**15-DAY EXPRESS TERMS
FOR
PROPOSED BUILDING STANDARDS
OF THE
DIVISION OF THE STATE ARCHITECT (DSA-AC)

REGARDING THE CALIFORNIA BUILDING CODE
CALIFORNIA CODE OF REGULATIONS, TITLE 24, PART 2

2013 CALIFORNIA BUILDING CODE**

Figure 11B-404.2.4.1
Maneuvering Clearances at Manual Swinging Doors and Gates

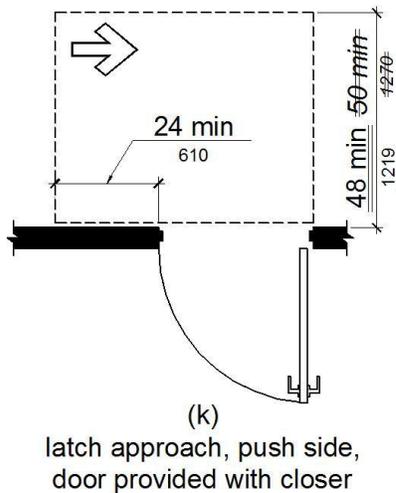
RATIONALE: DSA-AC is proposing an amendment to this figure to correct an inadvertent inconsistency between the figure and the corresponding table. Figure 11B-404.2.4.1(k) is being revised to show a 48" maneuvering clearance perpendicular to the doorway, reflecting the regulatory language of Table 11B-404.2.4.1.

Type of Use		Minimum Maneuvering Clearance	
Approach Direction	Door or Gate Side	Perpendicular to Doorway	Parallel to Doorway (beyond latch side unless noted)
From front	Pull	60 inches (1524 mm)	18 inches (457 mm) ⁵
From front	Push	48 inches (1219 mm)	0 inches (0 mm) ¹
From hinge side	Pull	60 inches (1524 mm)	36 inches (914 mm)
(begin single strikeout) From hinge side (end single strikeout)	(begin single strikeout) Pull (end single strikeout)	(begin single strikeout) 54 inches (1370 mm) (end single strikeout)	(begin single strikeout) 42 inches (1065 mm) (end single strikeout)
From hinge side	Push	(begin single strikeout) 42 inches (1065 mm) (end single strikeout) (begin single underline) <u>44 inches (1118 mm)</u> ² (end single underline)	22 inches (559 mm) ³
From latch side	Pull	(begin single strikeout) 48 inches (1220 mm) (end single strikeout) (begin single underline) <u>60 inches (1524 mm)</u> (begin single strikeout) ⁴ (end single strikeout) (end single underline)	24 inches (610 mm)

From latch side	Push	(begin single strikeout) 42 inches (1065 mm) (end single strikeout) (begin single underline) <u>44 inches (1118 mm)</u> ⁴ (end single underline)	24 inches (610 mm)
<p>1. Add 12 inches (305 mm) if closer and latch are provided. 2. Add (begin single strikeout) 6 inches (150 mm) (end single strikeout) (begin single underline) <u>4 inches (102 mm)</u> (end single underline) if closer and latch are provided. 3. Beyond hinge side. 4. Add (begin single strikeout) 6 inches (150 mm) (end single strikeout) (begin single underline) <u>4 inches (102 mm)</u> (end single underline) if closer is provided. (begin single underline) <u>5. Add 6 inches (152 mm) at exterior side of exterior doors.</u> (end single underline)</p>

Figure 11B-404.2.4.3
Maneuvering Clearances at Recessed Doors and Gates

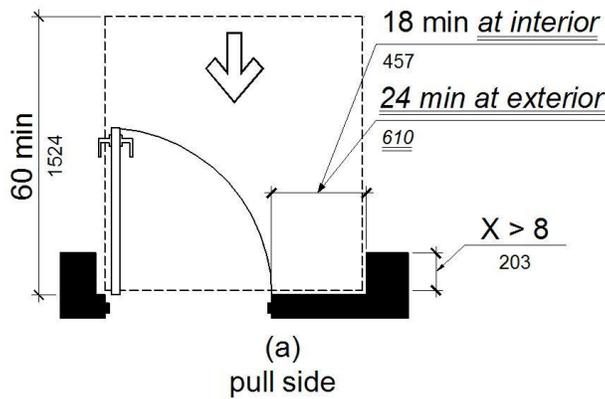
RATIONALE: DSA-AC received public comment stating that the language of this section is not consistent with the 2010 CBC, Sections 11B-1133B.2.4.2 and 1133B.2.4.5. The current CBC requirements provide an 18 inch maneuvering clearance at interior doors and a 24 inch maneuvering clearance at exterior doors. DSA-AC is proposing to amend 11B-404.2.4.3 and Figure 11B-404.2.4.3 to maintain the higher level of accessibility currently provided by the 2010 CBC.

11B-404.2.4.3 Recessed Doors and Gates. Maneuvering clearances for forward approach shall be provided when any obstruction within 18 inches (457 mm) of the latch side of (begin double underline) an interior (end double underline) doorway (begin double underline), or within 24 inches (610 mm) of the latch side of an exterior doorway. (end double underline) projects more than 8 inches (203 mm) beyond the face of the door, measured perpendicular to the face of the door or gate.

Figure 11B-404.2.6
Doors in Series and Gates in Series

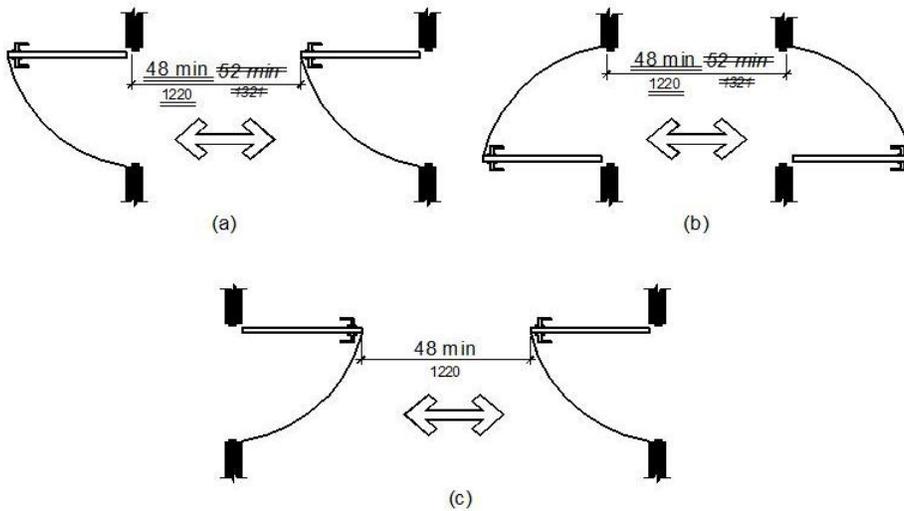
RATIONALE: DSA-AC is proposing an amendment to these figures to correct inadvertent inconsistencies between the figure and the corresponding text. Figures 11B-404.2.6 (a) & (b) are being revised to show a 48" maneuvering clearance at doors or gates in series, reflecting the regulatory language of 11B-404.2.6.

11B-404.2.6 Doors in Series and Gates in Series. The distance between two hinged or pivoted doors in series and gates in series shall be 48 inches (1219 mm) minimum plus the width of doors or gates swinging into the space.

Figure 11B-607.2
Clearance for Bathtubs

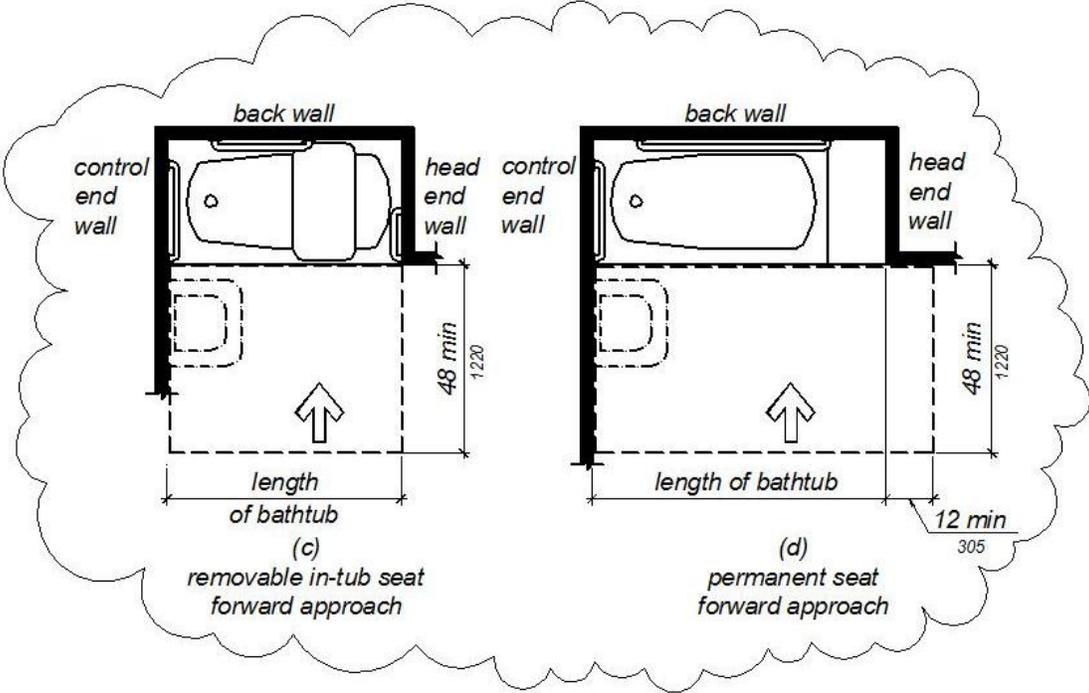
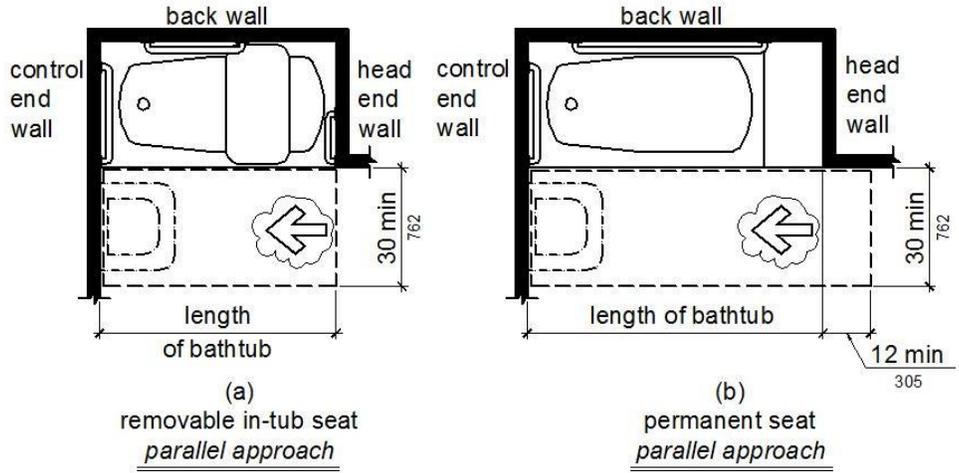
RATIONALE: DSA-AC is proposing to amend Figure 11B-607.2 to illustrate the clearance requirements for both forward and parallel approach consistent with the amendments proposed in the 45-day comment period. Diagrams (a) and (b) will be revised to include directional arrows indicating a parallel approach to the bathtubs. New diagrams (c) and (d) will be added indicating 48" wide minimum clearances and a forward approach to the bathtubs.

11B-607.2 Clearance. Clearance in front of bathtubs shall extend the length of the bathtub and shall be (begin single underline) **48 inches (1219 mm) wide minimum for forward approach and** (end single underline) 30 inches (762 mm) wide minimum (begin single underline) **for parallel approach** (end single underline) . A lavatory complying with 11B-606 shall be permitted at the control end of the clearance. Where a permanent seat is provided at the head end of the bathtub, the clearance shall extend 12 inches (305 mm) minimum beyond the wall at the head end of the bathtub.
